Access Compliance Report

Public Rights-of-Way

(Curb Ramps)

Intersection ID: 7793	Main Street: JEFF_ADAMS_DR	Cross Street: STATESVILLE_AV	Location: SE
ADA ID: 7F79EC991DDD	Ramp Type: Perp	Initial Pass/Fail: Fail	Overall Compliance: No
Severity Score: 12.5			
Codes/Mitigation Info/Possible Solution		Field Measurements/Component Compliance

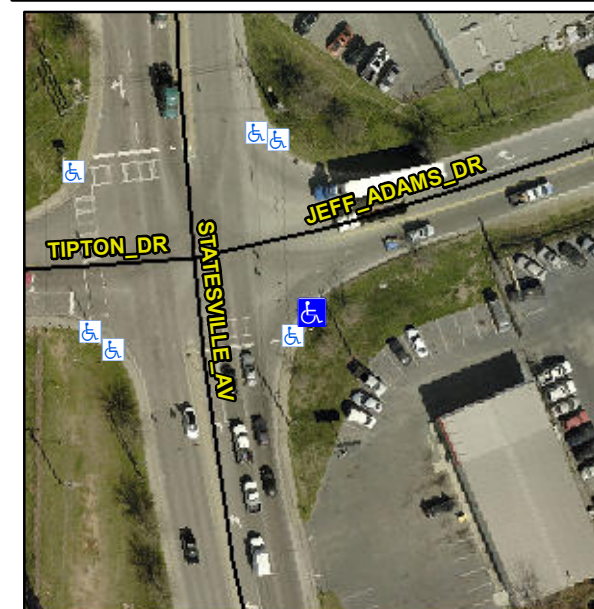
Not Found, R304.2.2

Compliance	Description	Data	Compliance	Description	Data
N/A	Ramp Length (in)	60.0	No	Ramp Slope (%)	9.3
Yes	Ramp Width (in)	48.0	Yes	Ramp XSlope (%)	1.7
N/A	Flare Type LT	N/A	N/A	Flare Type RT	N/A
N/A	Flare Slope LT (%)	N/A	N/A	Flare Slope RT (%)	N/A
N/A	Flare Traversable LT?	N/A	N/A	Flare Traversable RT?	N/A
N/A	Landing Length (in)	N/A	N/A	DWS Provided?	N/A
N/A	Landing Width (in)	N/A	N/A	DWS Contrast?	N/A
N/A	Landing Slope (%)	N/A	N/A	DWS Length (in)	N/A
N/A	Landing X Slope (%)	N/A	N/A	DWS Full Width?	N/A
N/A	Landing Curb? (Y/N)	N/A	N/A	DWS Offset (in)	N/A
N/A	Shared Landing?	N/A			
N/A	Gutter Ponding?	N/A	N/A	Gutter Slope (%)	N/A
N/A	Gutter Lip Ht (in)	N/A	N/A	Gutter X Slope (%)	N/A
N/A	Painted X Walk1?	No	N/A	Painted X Walk2?	N/A
	X Walk 1 Direction	To N		X Walk 2 Direction	N/A
N/A	X Walk 1 Width (in)	N/A	N/A	X Walk 2 Width (in)	N/A
	X Walk 1 Slope (%)	1.9		X Walk 2 Slope (%)	N/A
	X Walk 1 X Slope (%)	0.6		X Walk 2 X Slope (%)	N/A

Remove & Replace Entire Ramp.
